Addendum No. 02

Memorial Stadium Modernization

Fieldhouse & Stadium

MADERA UNIFIED BID NO.: 073025
PBK PROJECT NO.: 20-51
DSA APPLICATION NO.: 02-121624 Fieldhouse
02-122784 Stadium

A1.4

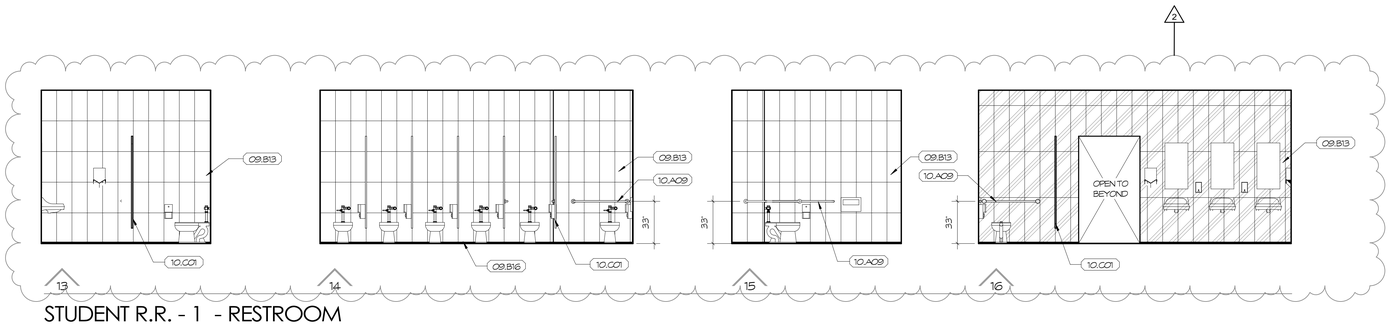
b. A1.4 – ENLARGED FLOOR PLAN & INT. ELEV.
   - Revised interior elevations.
   - Updated legend.
c. A2.2 – FINISH/ COLOR PLAN & SCHEDULE
   - Updated finish plan, color schedule, and notes.
d. A5.1 – EXTERIOR ELEVATIONS
   - Updated exterior elevations and legend.

AS.1

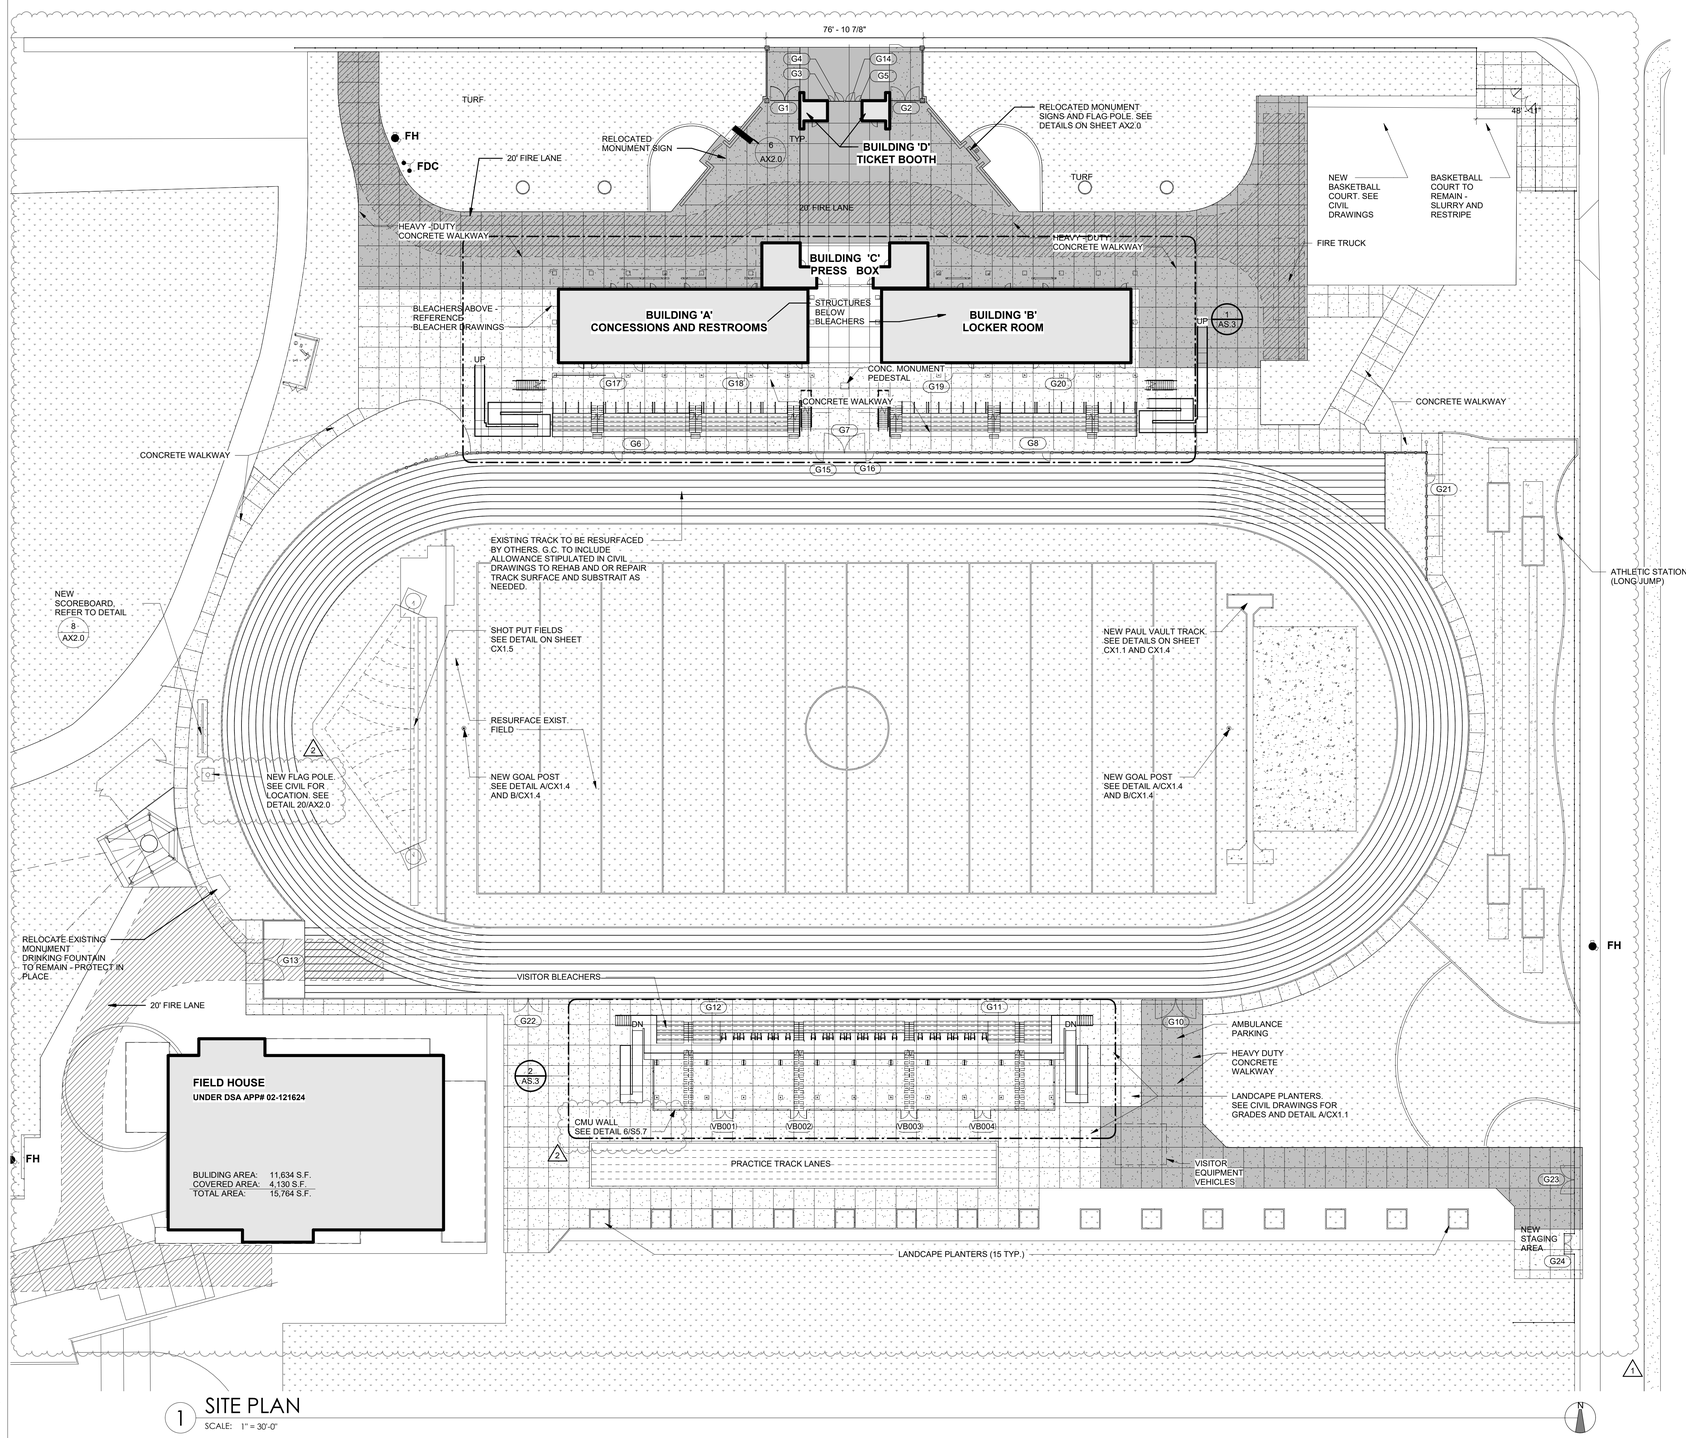
a. AS.1 – OVERALL SITE PLAN
   - Corrected detail reference
   - Added flag pole note on west side of track.
b. AS.3 – ENLARGED SITE PLAN
   - Corrected detail reference.
   - Added exterior elevations.
c. AS.4 – ELEVATIONS - HOME BLEACHERS
   - Added sheet.
d. AS.5 – ELEVATIONS - VISITOR BLEACHERS
   - Added sheet.
e. AA1.1 – FLOOR PLAN - BUILDING A
   - Removed OFCI note from Freezer and Refrigerator in Concessions A100.
f. AA5.1 – EXTERIOR ELEVATIONS - BUILDING A
   - Added CMU control joints note on elevations.
   - Updated legend.
g. AA7.2 – INTERIOR ELEVATIONS - BUILDING A
   - Corrected elevations.
   - Corrected legend.
h. AB5.1 – EXTERIOR ELEVATIONS - BUILDING B
   - Added CMU control joints note on elevations.
   - Updated legend.
i. AB7.1 – INTERIOR ELEVATIONS - BUILDING B
   - Corrected elevations and legend.

AD4.1

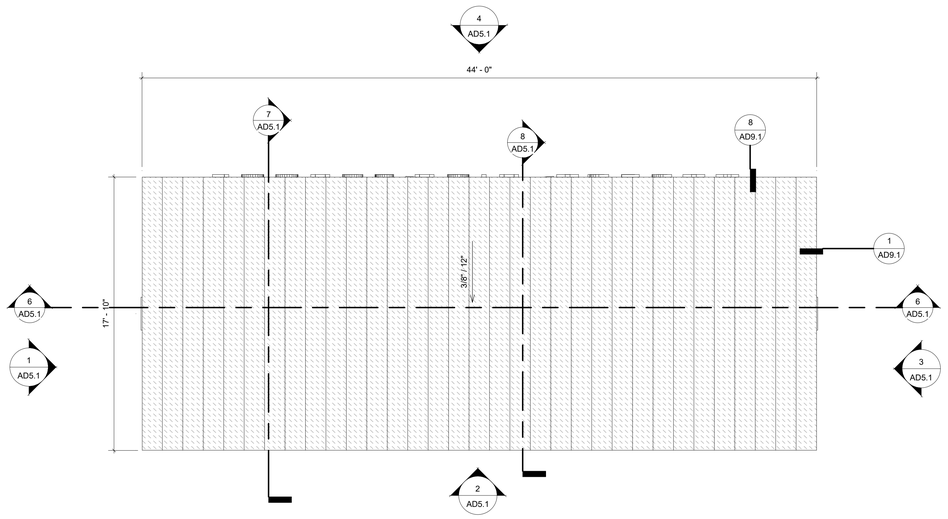
j. AB9.1 – SPECIALTY DETAILS
   - Removed detail 5.
k. AC1.1 – FLOOR PLAN - BUILDING C
   - Removed legend.
l. AC9.1 – SPECIALTY DETAILS
   - Revised storefront detail.
m. AD4.1 – ROOF PLAN - BUILDING D
   - Corrected legend.
n. AX3.2 – TYPICAL OPENING DETAILS – STOREFRONT
   - Removed details 01 and 06.
o. AX4.1 – ROOF DETAILS
   - Removed details 28 and 30.
p. AX8.0 – FINISH/ COLOR SCHEDULE
   - Revised Finish Plan.
   - Revised color schedule and notes.
q. AX8.1 – DOOR AND WIDNOW SCHEDULE
   - Updated door types.

S2.1A

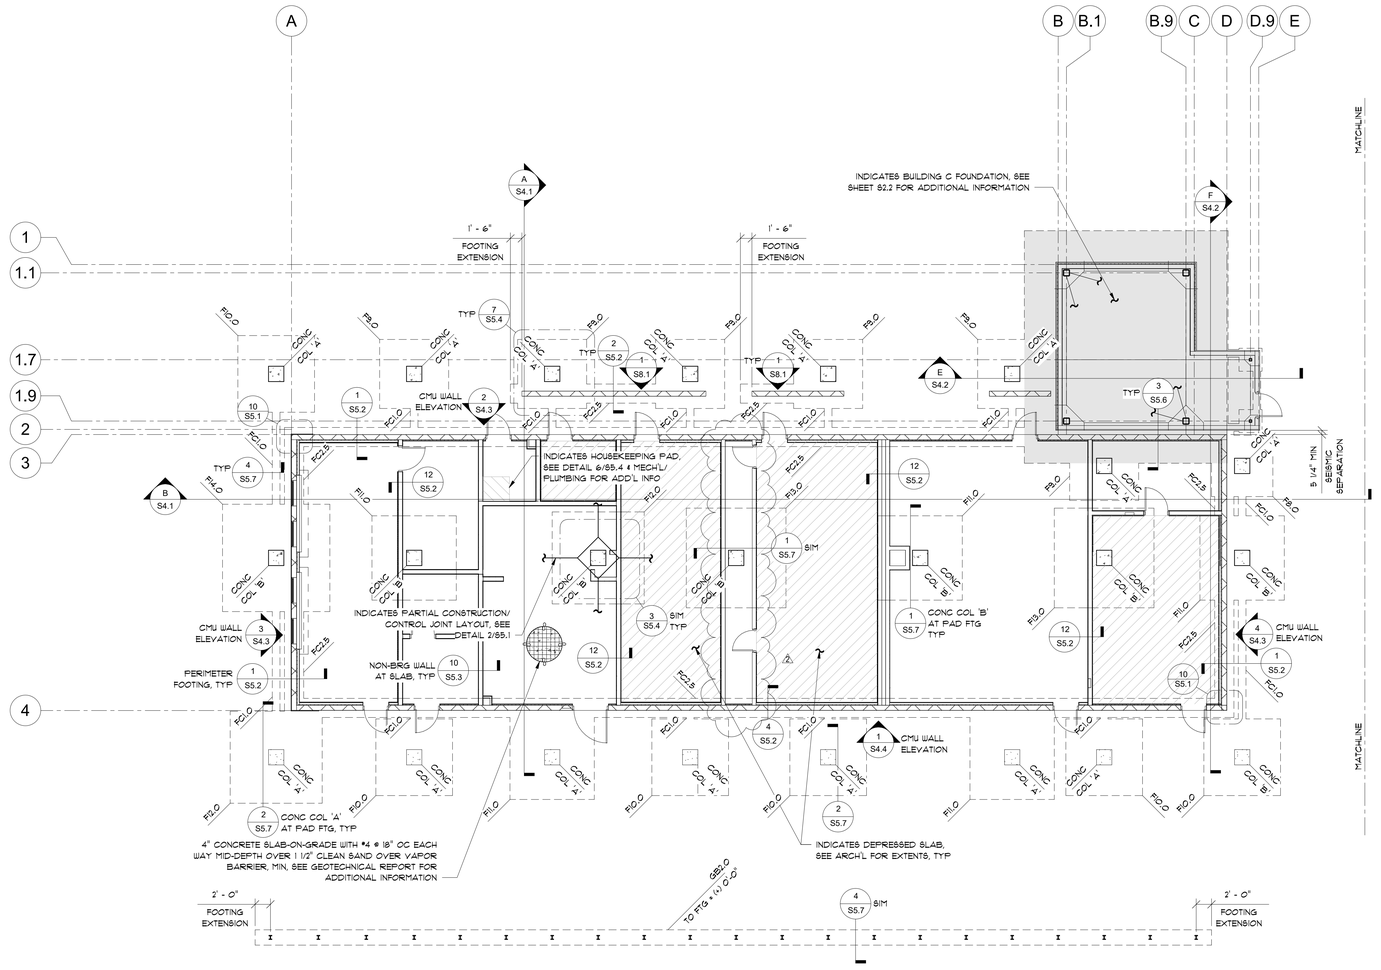
a. S2.1A – FOUNDATION PLAN - BUILDING A
   - Revised foundation plan.
   - Updated legend.
b. S2.1B – FOUNDATION PLAN - BUILDING B
   - Revised foundation plan.
   - Updated legend.
c. S3.4 – FLOOR FRAMING & CURB LAYOUT PLANS - BULIDING C
   - Added detail 2.
   - Updated legend.
d. S6.5 – METAL STUD FRAMING DETAILS
   - Revised detail.

21 August 2025 10:31 AM p:\2023\23073 modera usd – modera hs stadium locker addition\4-drawings\5 PLPHASE-2 Stadium\PS.1 – PLUMBING SITE PLAN.dwg gustavo

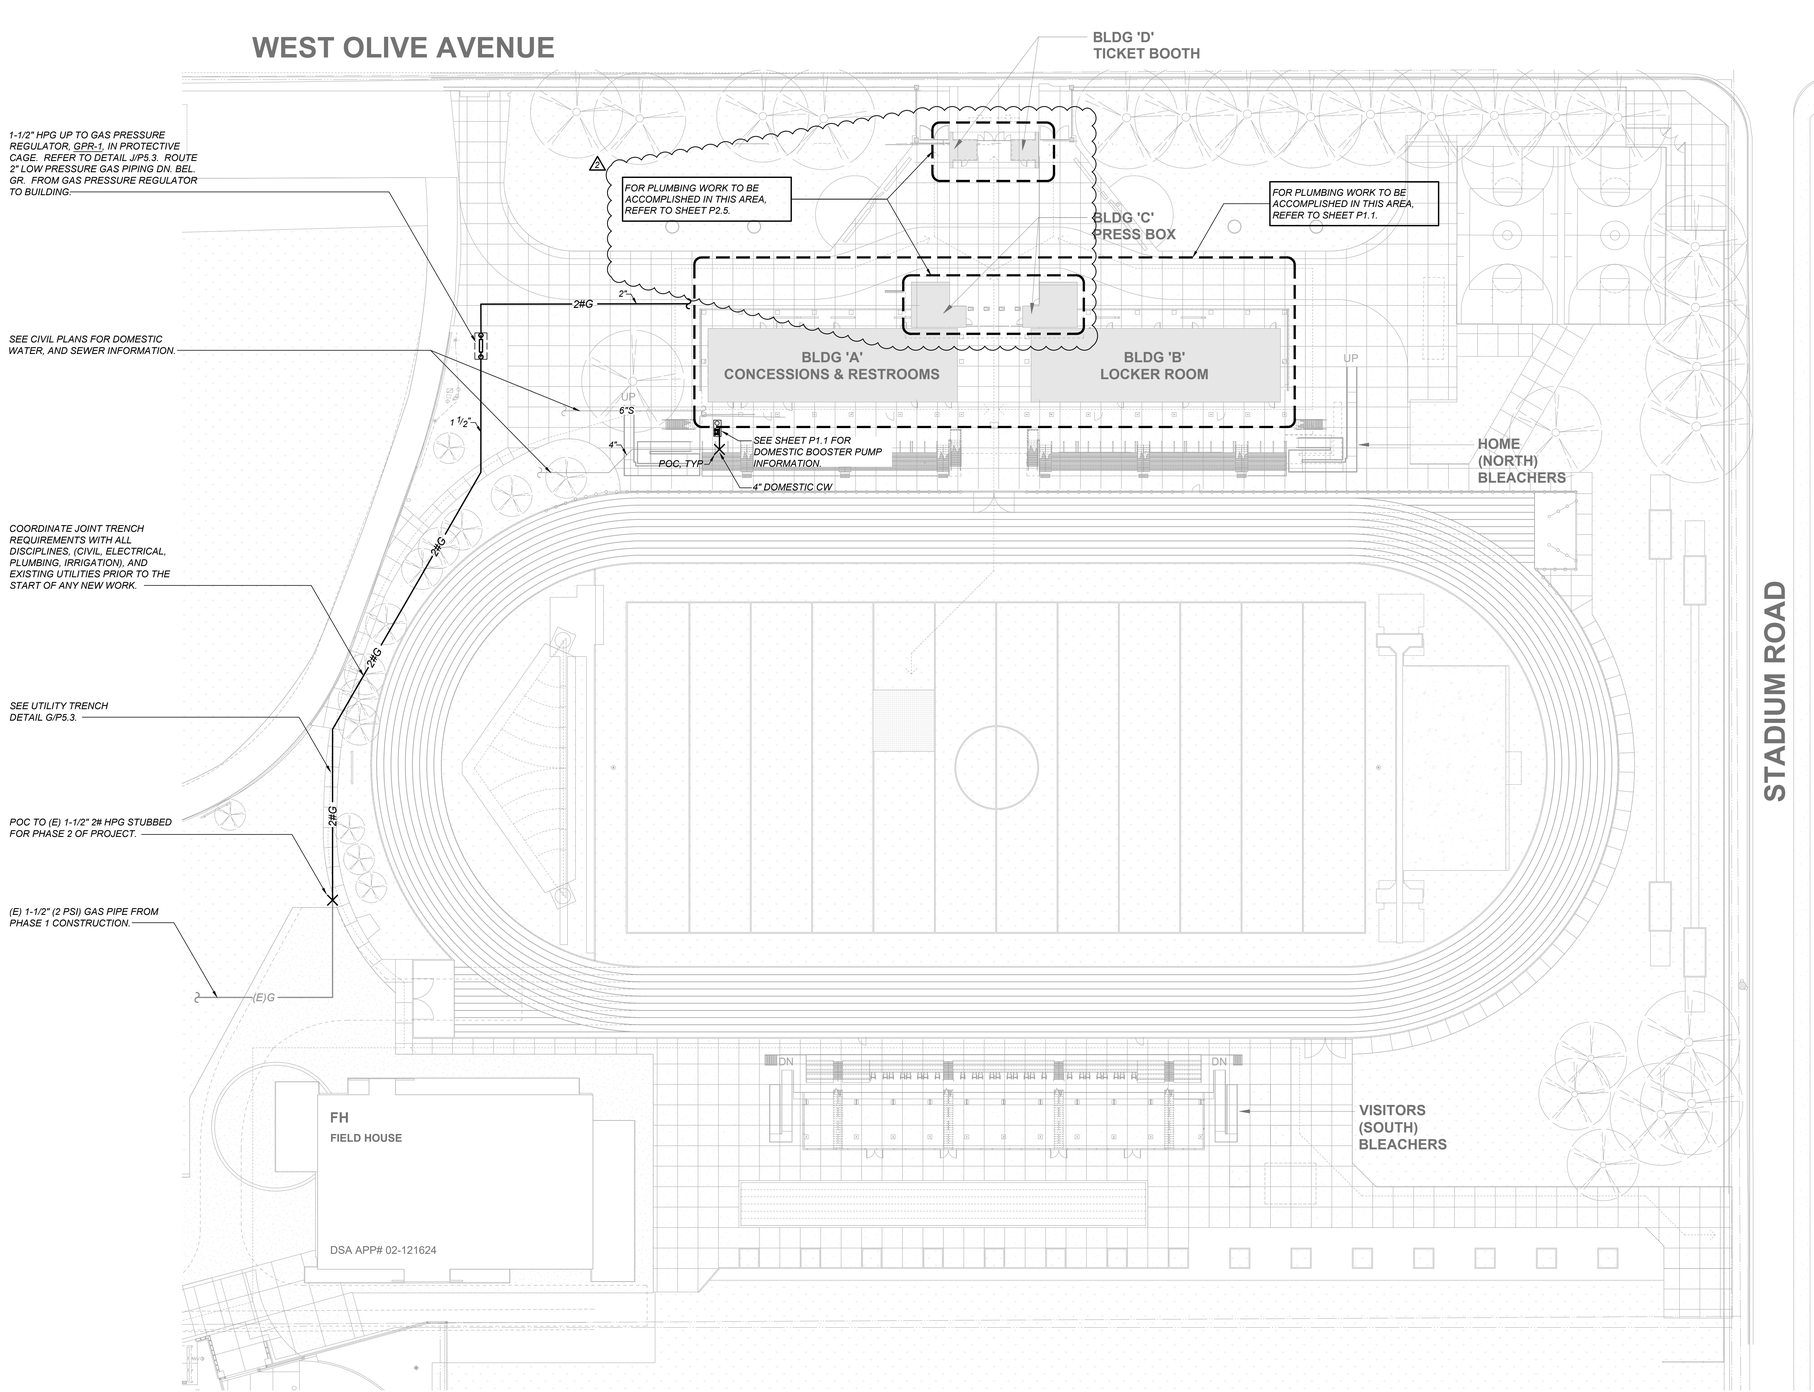
a. PS.1 – PLUMBING SITE PLAN
   - Added callout for added scope of work.
b. P2.1 – ENLARGED PLUMBING PLAN -EAST (SEWER, DRAIN, & VENT)
   - Added condensate drain and drywells.
c. P2.2 – ENLARGED PLUMBING PLAN -WEST (SEWER DRAIN & VENT)
   - Added condensate drain and drywells.
d. P2.5 – ENLARGED PLUMBING PLAN -PRESSBOX

1 ELECTRICAL SITE PLAN
SCALE: 1"=30'-0"

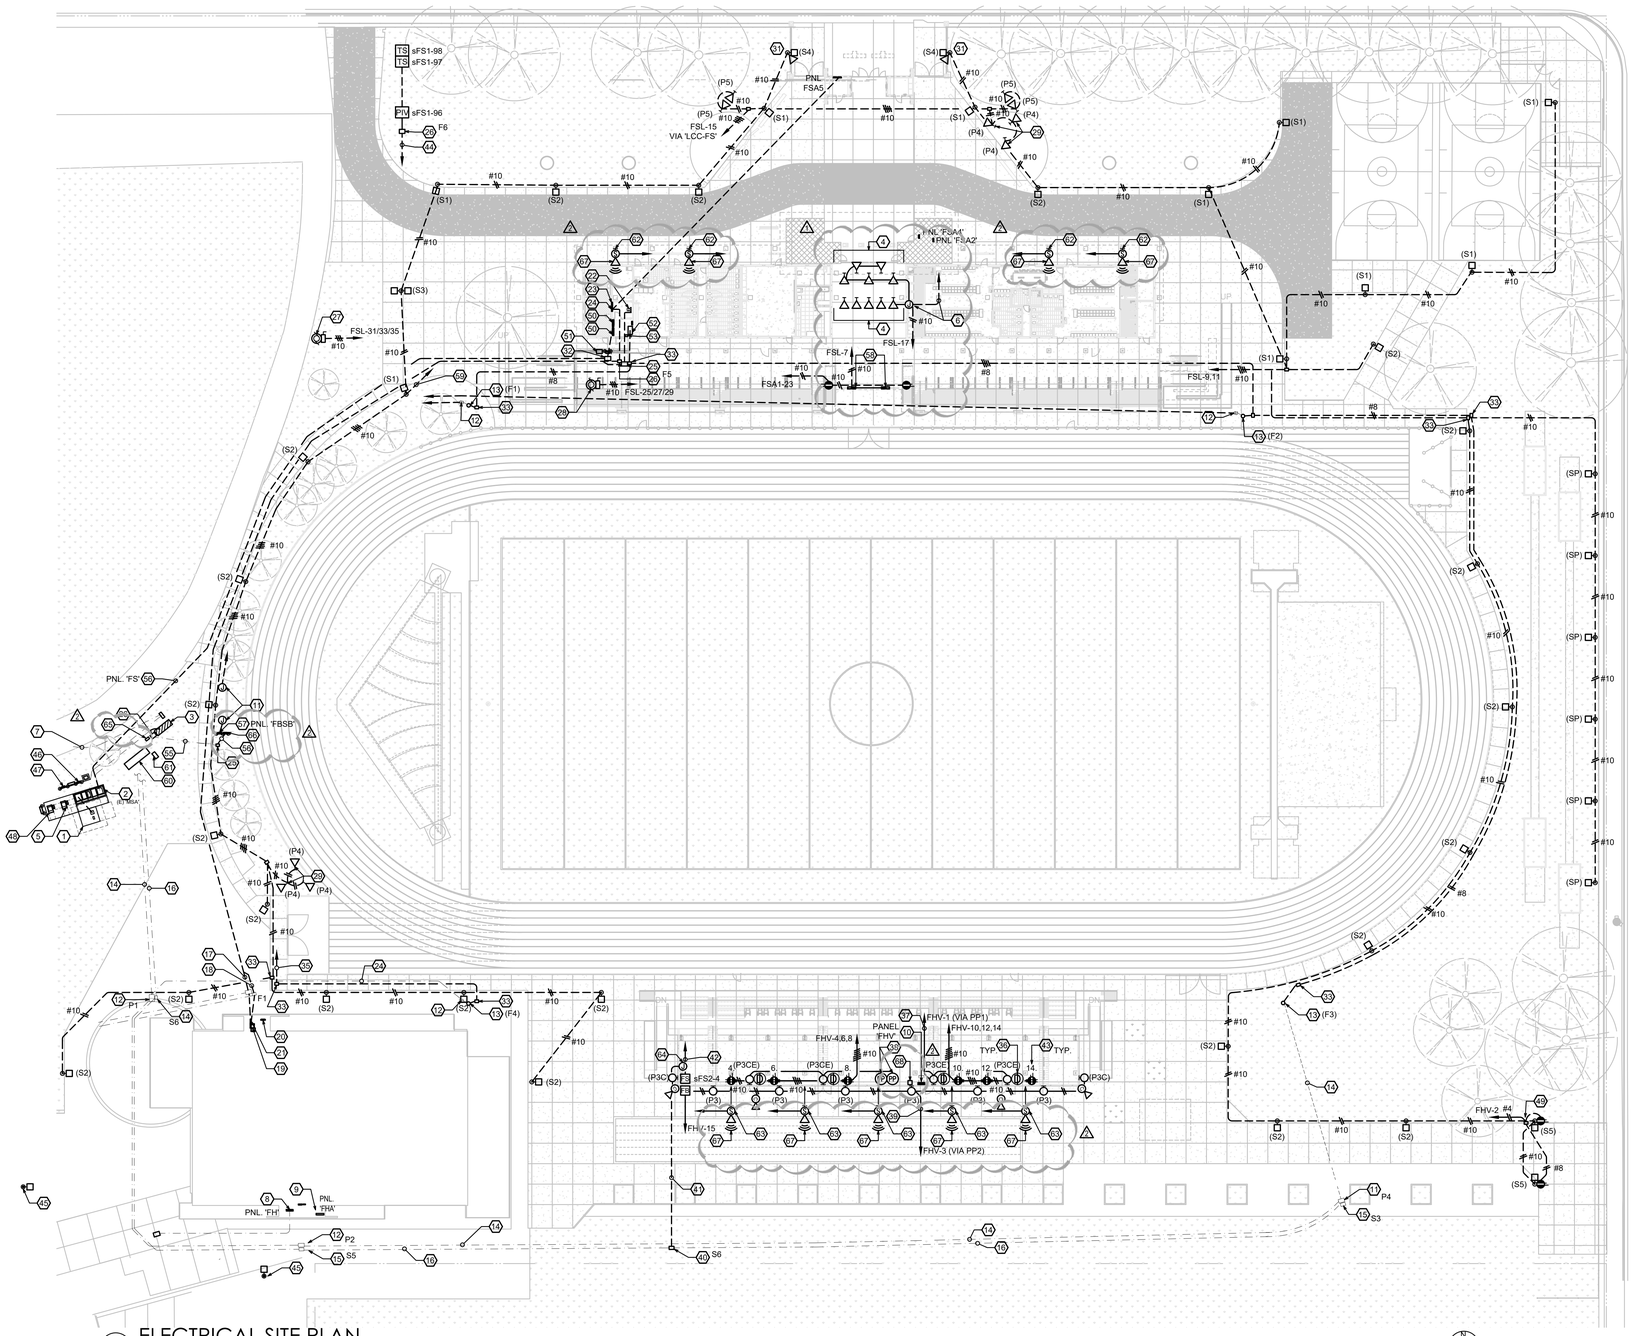
a. ES1.2 – ENLARGED ELECTRICAL SITE PLAN
- Modified fixture type 'P6' mounting between buildings 'A' and 'B'.
- Added WAP to speaker support poles.
- Added the replacement of the MUSCO Control and Monitoring Cabinet.
- Added fused disconnect at panel 'FBSB'.
- Added outdoor IDF under visitor bleachers.
- Modified Keynotes 4 & 13.
- Added Keynotes 65 through 68.
